City of Phoenix
PLANNING & DEVELOPMENT DEPARTMENT

Subject: P.H.O. APPLICATION NO. PHO-1-26--Z-29-23-7(8) – Notice of Pending Actions by the Planning Hearing Officer

APPLICATION NO: PHO-1-26--Z-29-23-7(8)

Request For: Stipulation Modification

west elevation

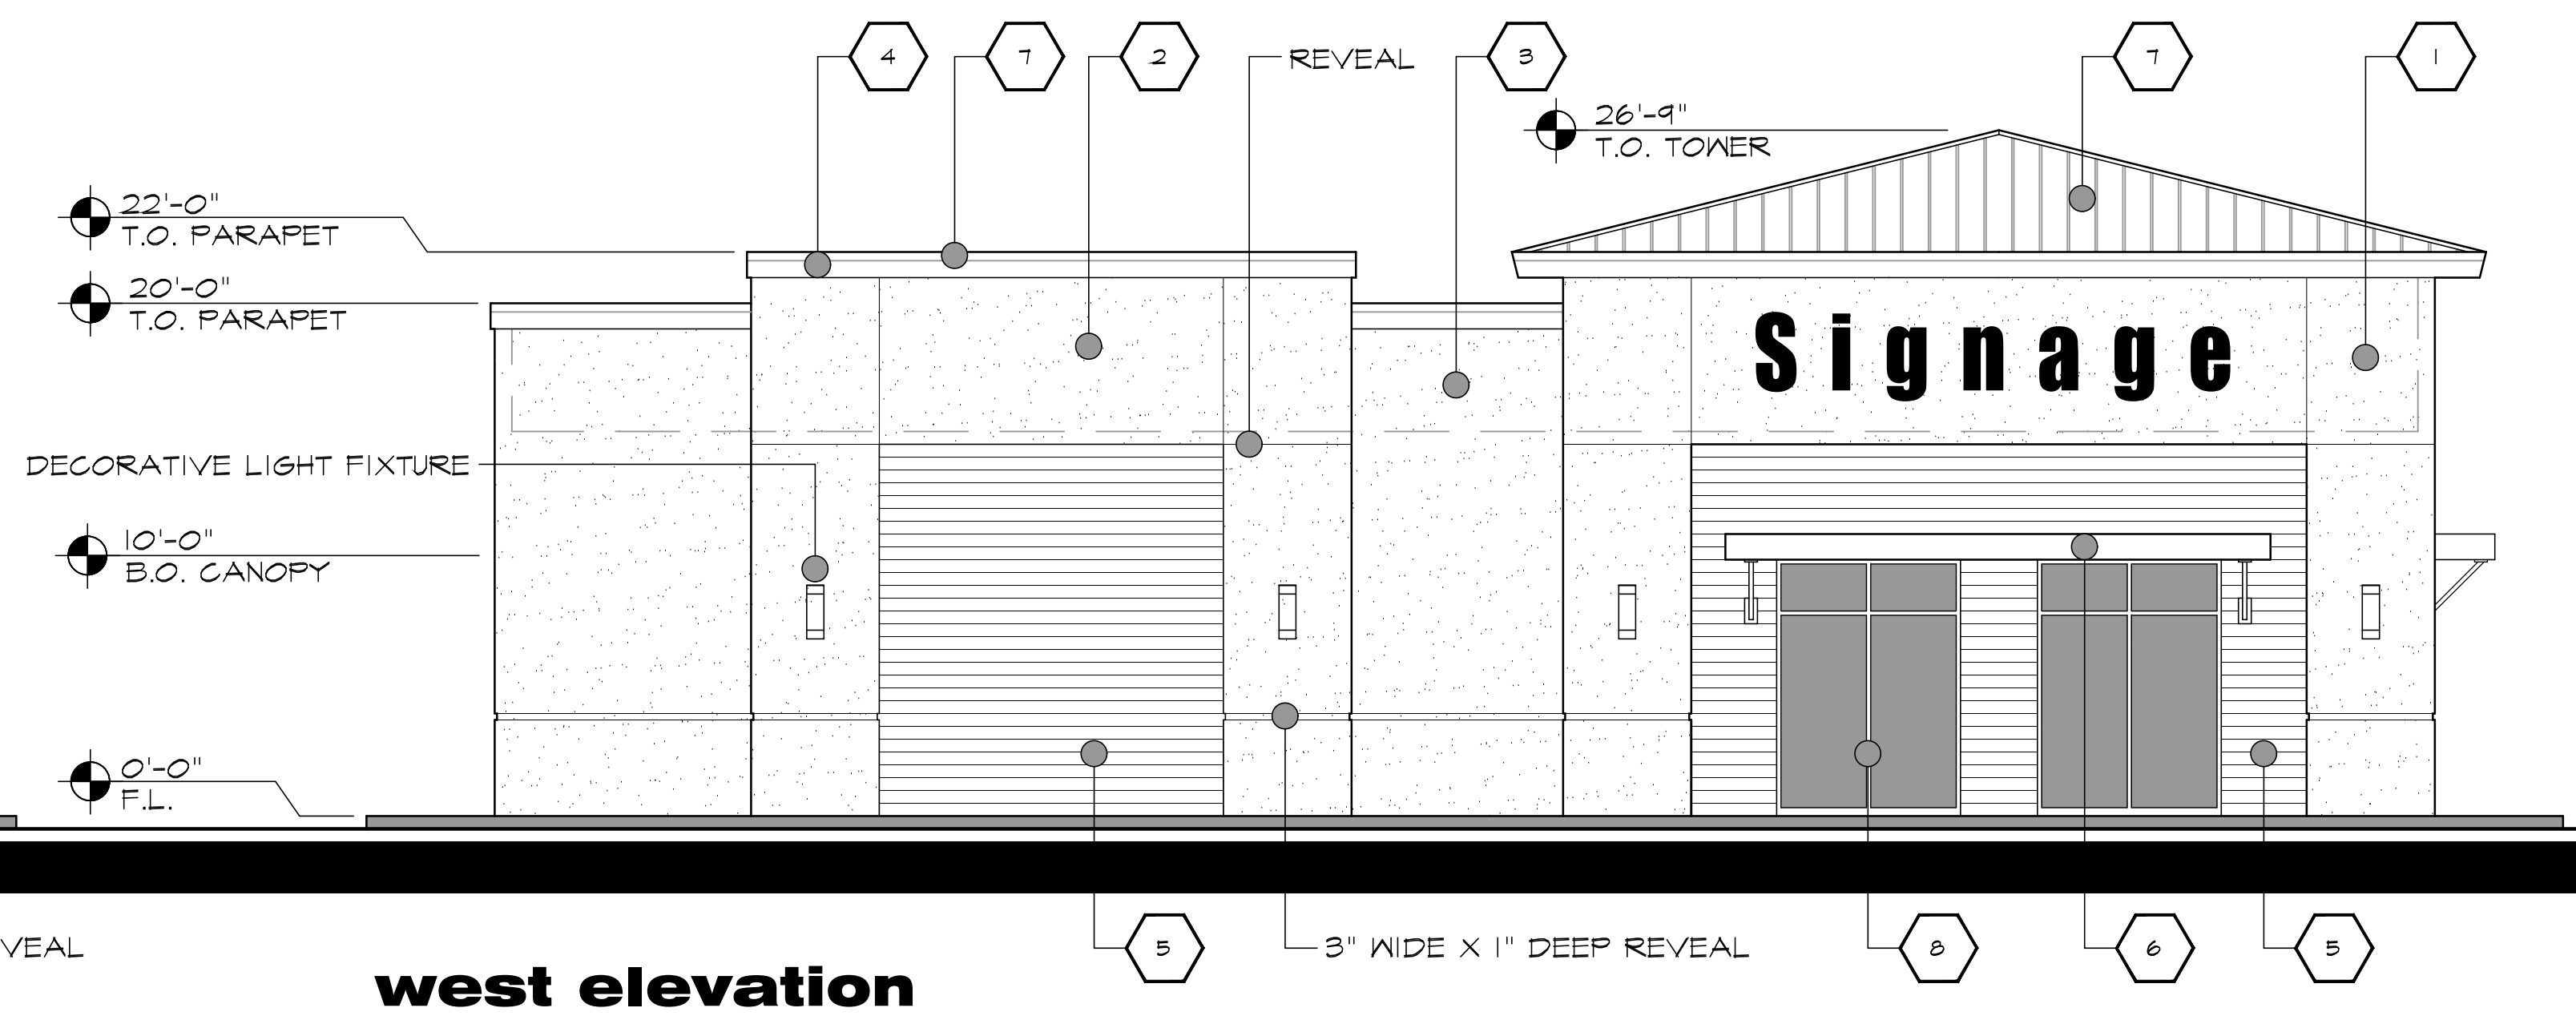
We respectfully request your review of the site plan and elevations for Lot 4 and the forementioned modifications and deletions of stipulations in Z-29-23-7. Thank you for your time and attention to this matter.
